Report from Kent Highways on request of reduction of speed limit from 50mph to 40 mph

Request for a reduced speed limit from 50mph to 40mph

Location 1: North of junction with Highland Road

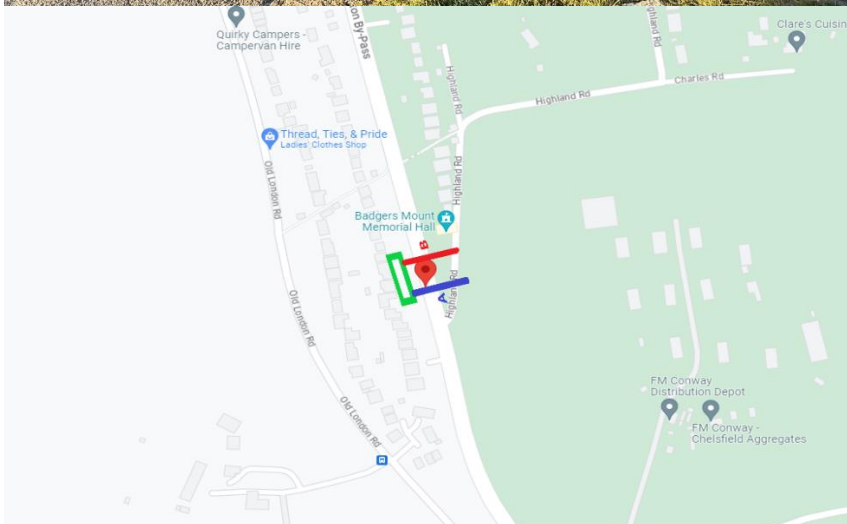
Northbound – (travelling towards Hewitts Roundabout)			Southbound – (travelling towards Badgers Mount Roundabout)		
Total Vehicles (no.)	85% speed (mph)	Mean speed (mph)	Total Vehicles (no.)	85% speed (mph)	Mean speed (mph)
32833	45.8	40.2	50418	45.5	40.3

The data suggests that average speeds are good being almost 10mph under the posted speed limit of 50mph. HADMS speed data would appear to support this also indicating average speeds significantly below the posted speed limit and generally around 40mph or a little either side. However, there would likely be poor overall compliance with a signed only 40mph speed limit with the ATC data predicting only 40%-50% compliance levels.

Location 2: North of junction with Badgers Road

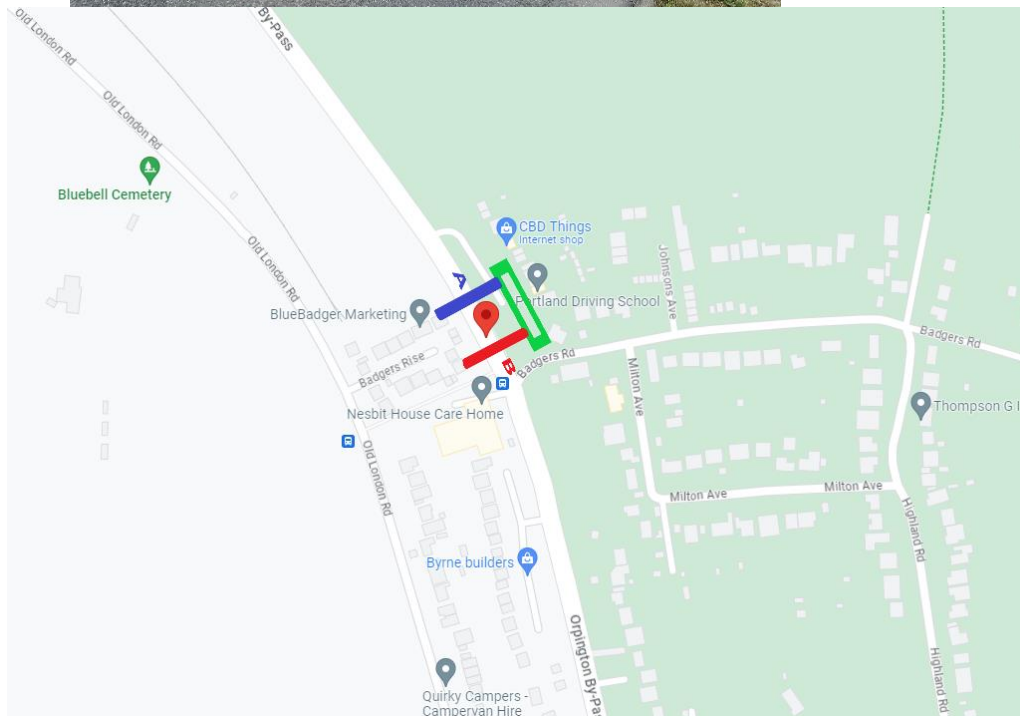
Northbound – (travelling towards Hewitts Roundabout)			Southbound – (travelling towards Badgers Mount Roundabout)		
Total Vehicles (no.)	85% speed (mph)	Mean speed (mph)	Total Vehicles (no.)	85% speed (mph)	Mean speed (mph)
33512	46.6	40.9	50948	46	40.4
